**DOCUMENT 00 90 00
ADDENDUM**

ADDENDUM NO. [1] Date: September 29, 2020

**RE: WITC – RICE LAKE CAMPUS
HEAT PUMPS
1900 COLLEGE DRIVE
RICE LAKE, WI
HSR PROJECT NO. 20022-4**

**FROM: HSR Associates, Inc
100 Milwaukee Street
La Crosse, WI 54603
(608) 784-1830**

DEMOLITION/REVISION NOTES

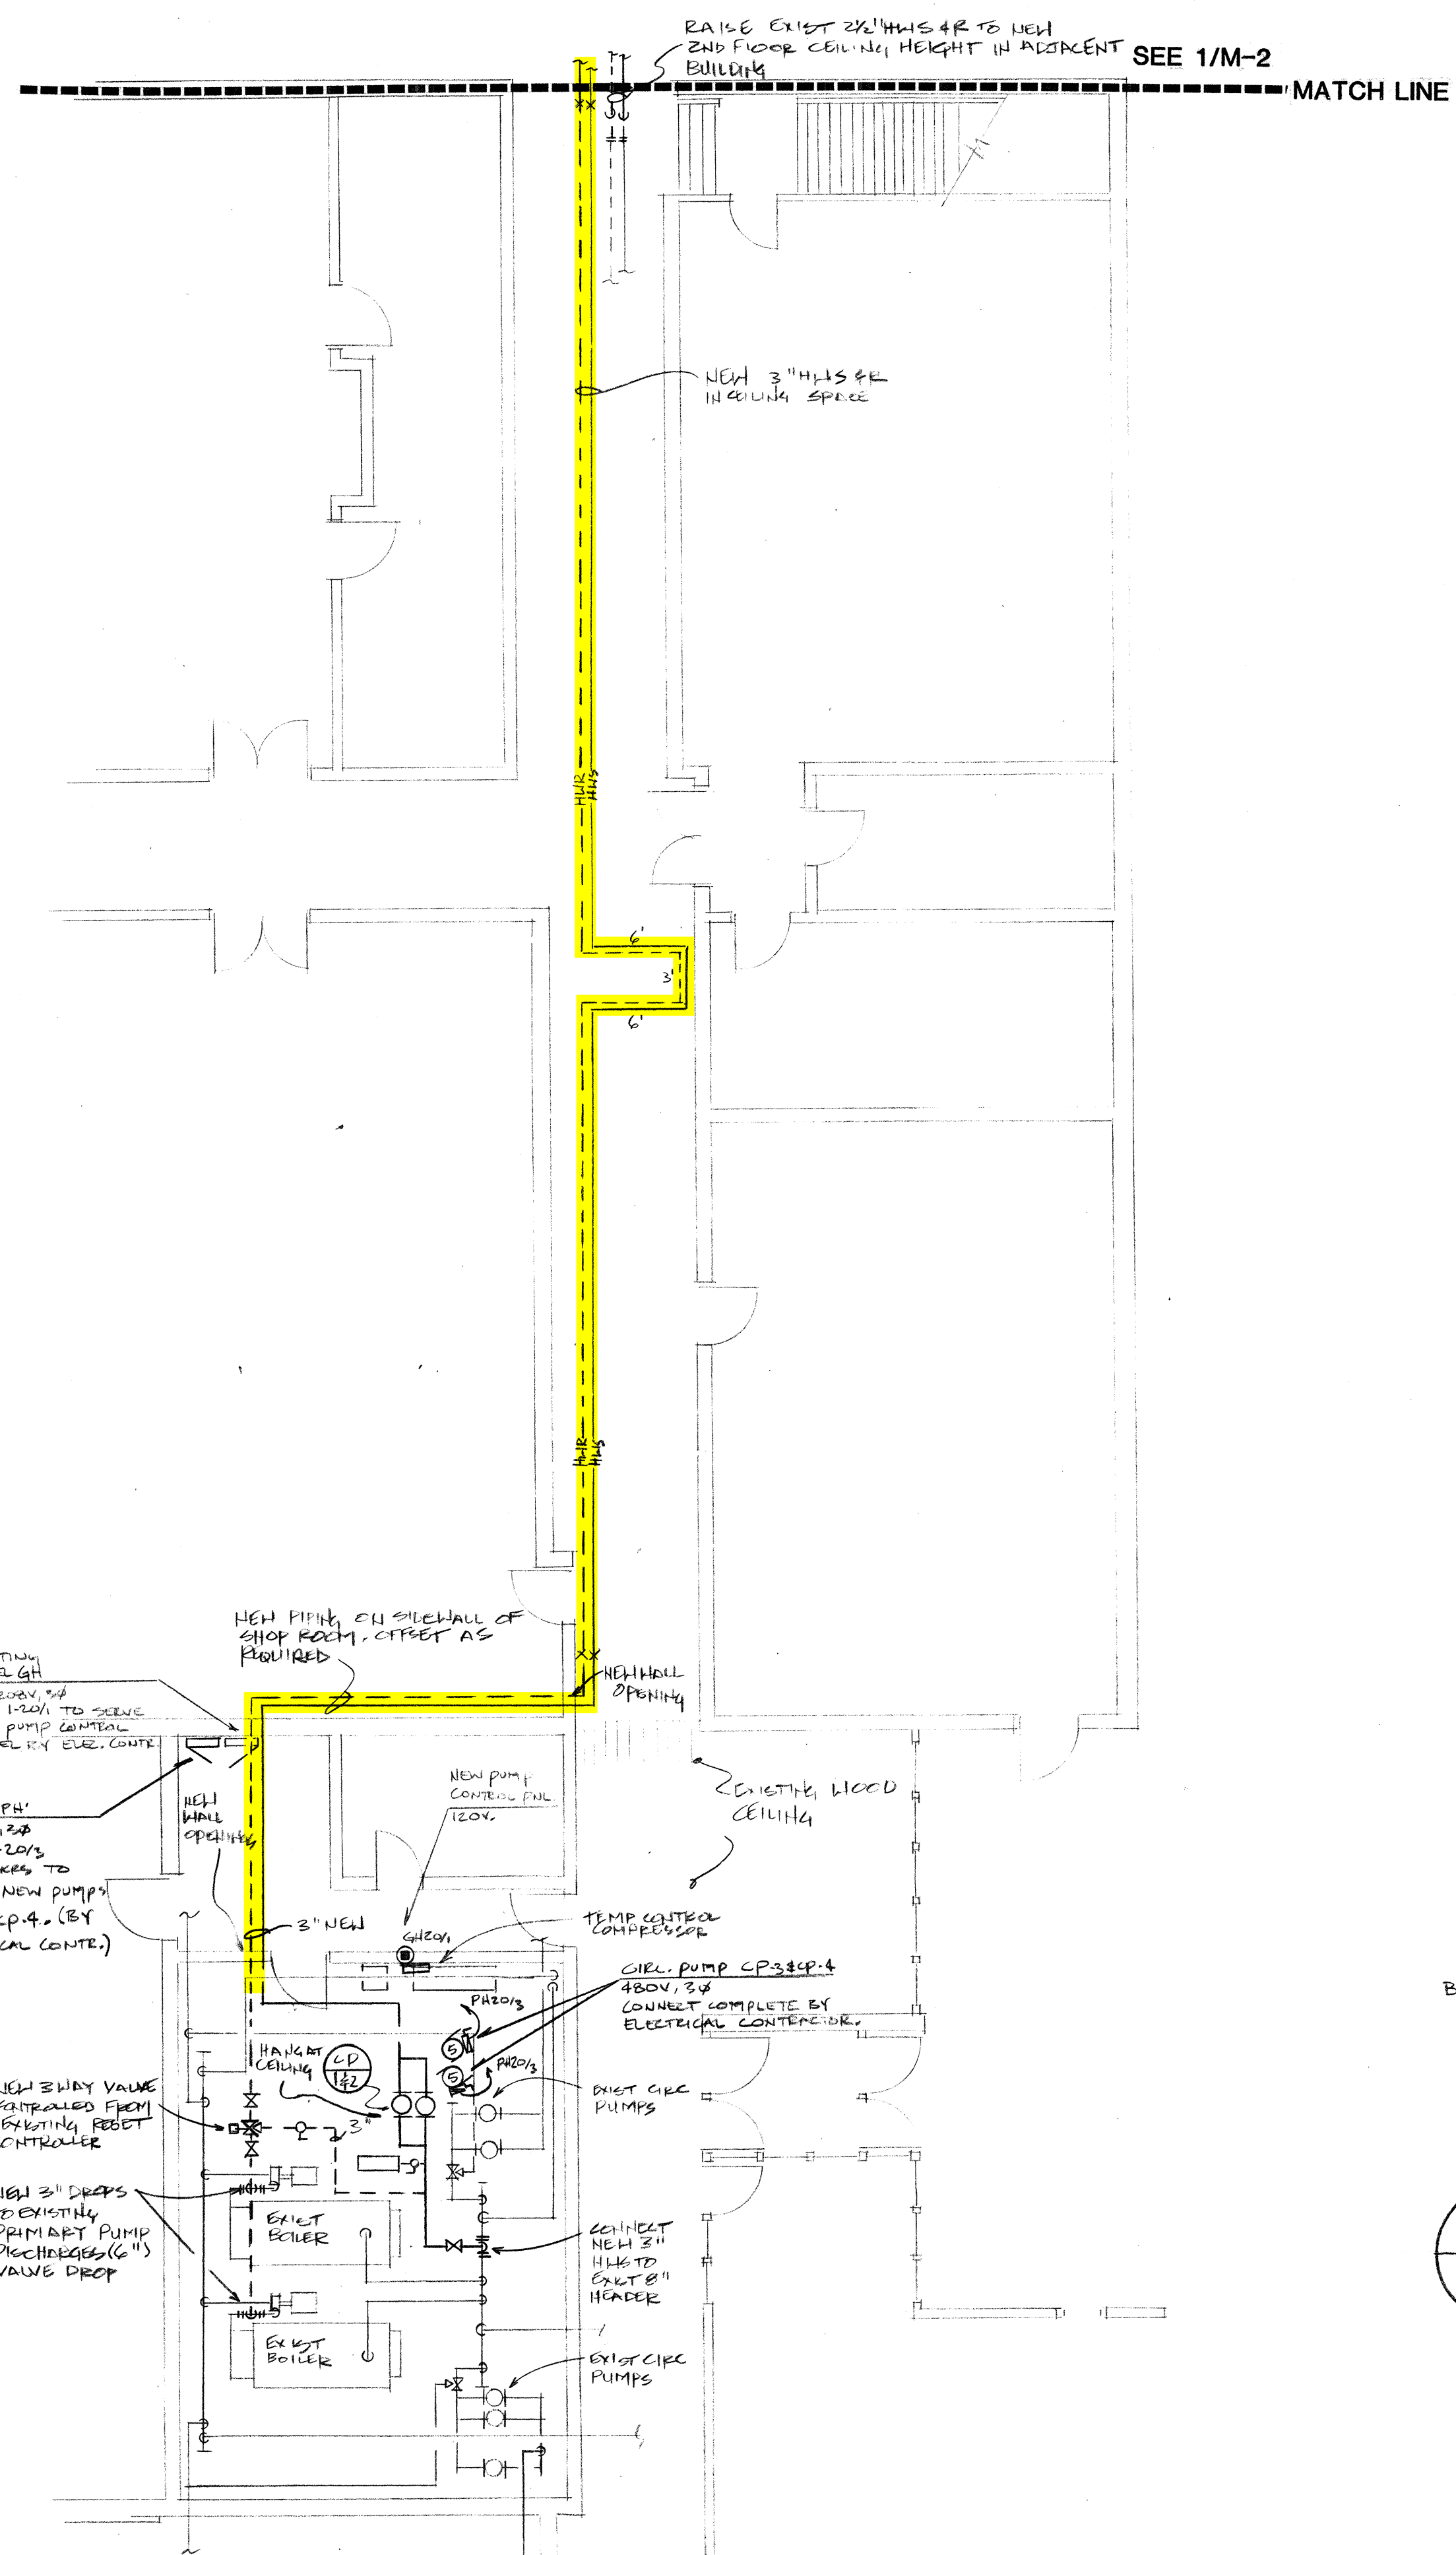
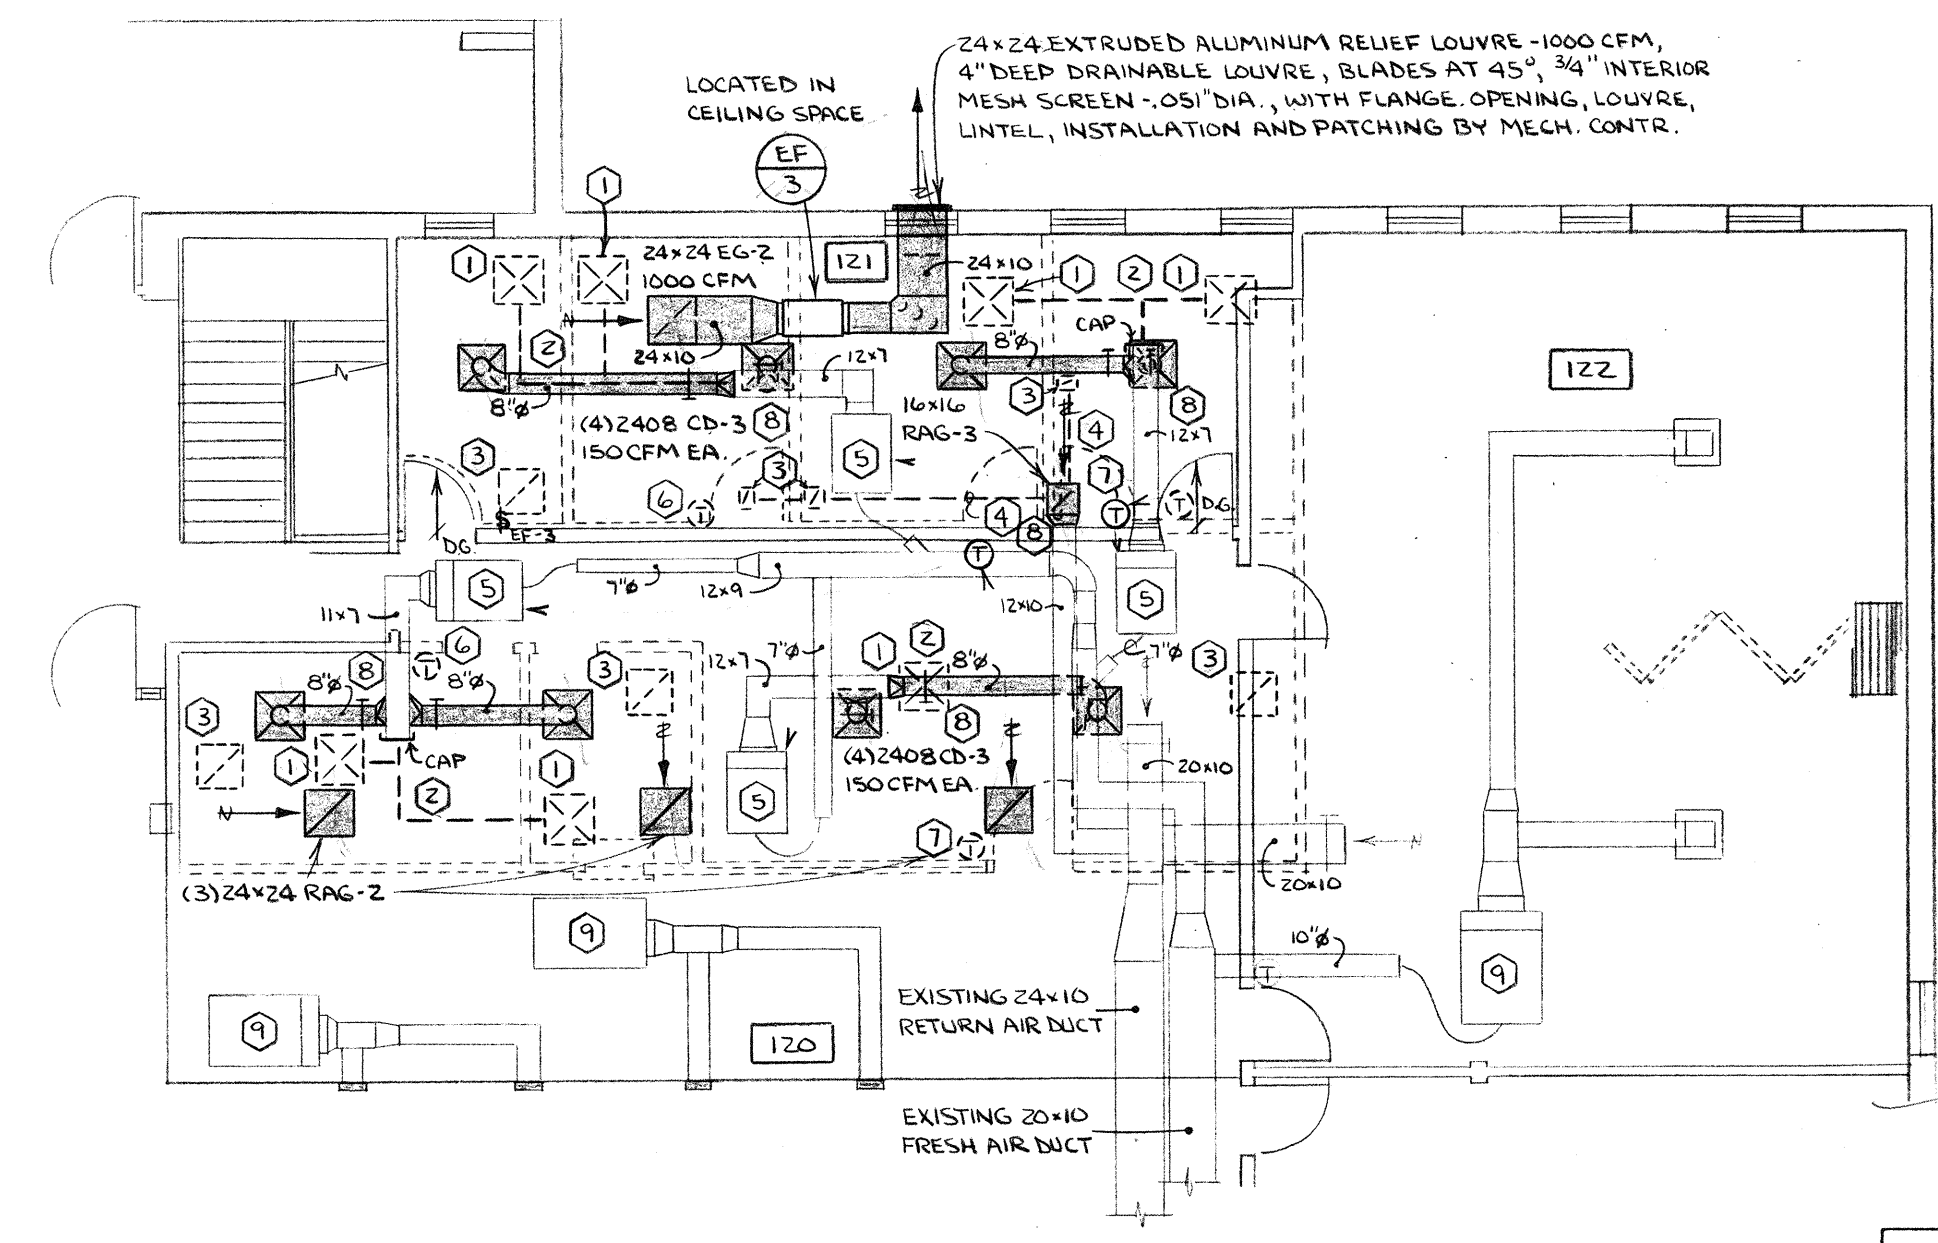
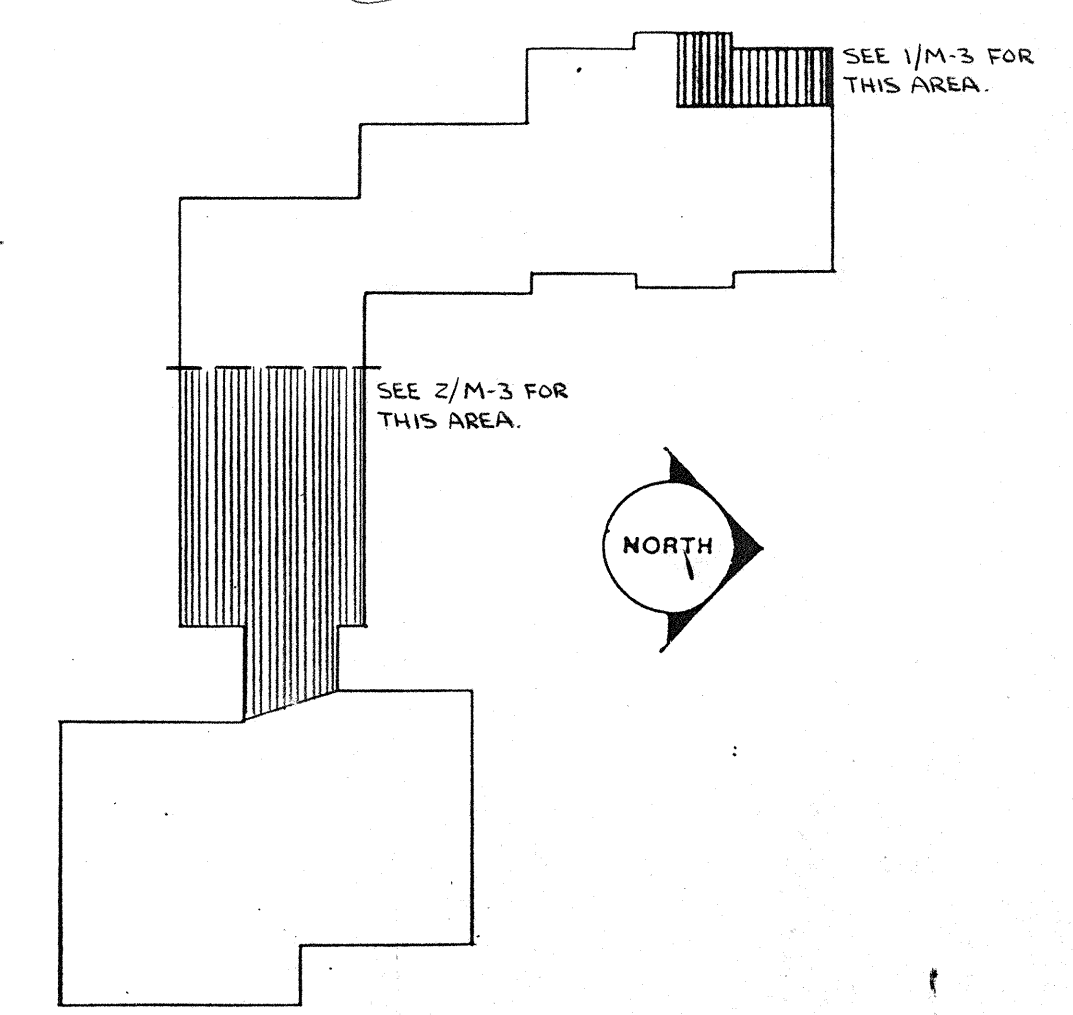
- a. Clarification: Reference attached supplemental record drawings for existing hot water heating pipe size and route between construction area and boiler room. Main shut-off valves do not exist between the project area and the boiler room. Contractor to provide necessary means and methods for connection of new to existing pipes. Add valves at new to existing connection. Coordinate all system and equipment shut downs with owner representative.
